**PUBLIC ADVOCATES OFFICE DATA REQUEST:
CALADVOCATES-SDGE-2022 WMP-06
SDG&E RESPONSE**

**Date Received: February 18, 2022
Date Submitted: February 24, 2022**

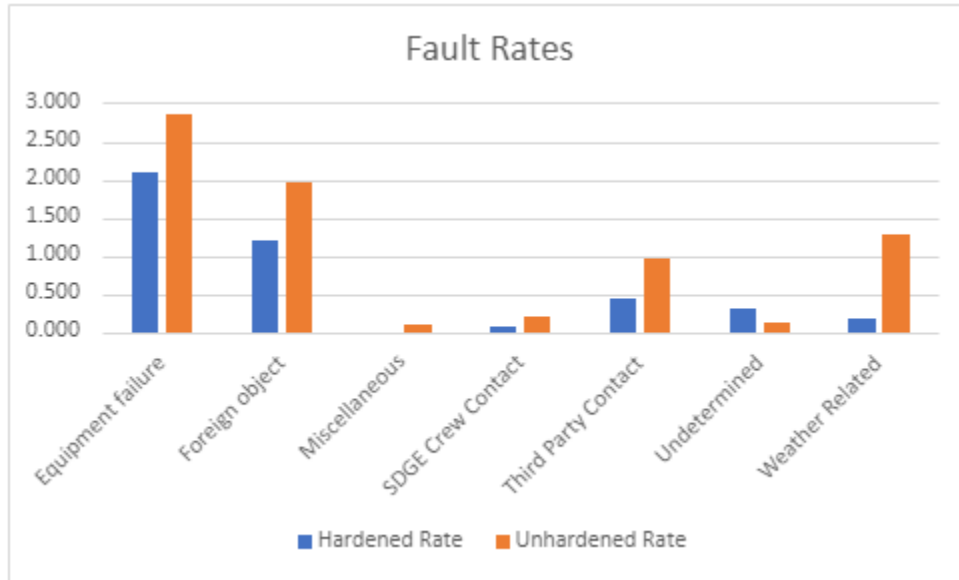
In section 4.4.2.3 of SDG&E’s 2022 WMP titled “Impact of Overhead Distribution Hardening at Reducing Overhead Faults,” SDG&E provides a graph in section 6 titled, “Faults By Cause Type” that highlights events caused by certain faults before and after hardening efforts. SDG&E states: “On average, the unhardened system saw an average of 13.50 risk events per 100 miles per operating year while the hardened system saw an average of 7.49 risk events per 100 miles per operating year. This represents a 45 percent reduction in risk in hardened system areas.”

- (a) Explain why SDG&E uses “per 100 miles per operating year” figures in section 4.4.2.3 of its 2022 WMP.
- (b) Explain why SDG&E’s graph in section 6 of section 4.4.2.3 of SDG&E’s 2022 WMP is not shown as a per 100 mile basis.

- a) SDG&E uses faults per 100 miles per operating year to better directly compare the before and after effects of hardening efforts. Using a set number of miles per operating year allows data to be normalized for a comparison between hardened and unhardened circuits.
- b) SDG&E shows the graph of faults by cause type over the five-year study period to demonstrate the reduction by driver. These can be converted into a per 100 miles per operating year rate. A graph that has been normalized is provided below:
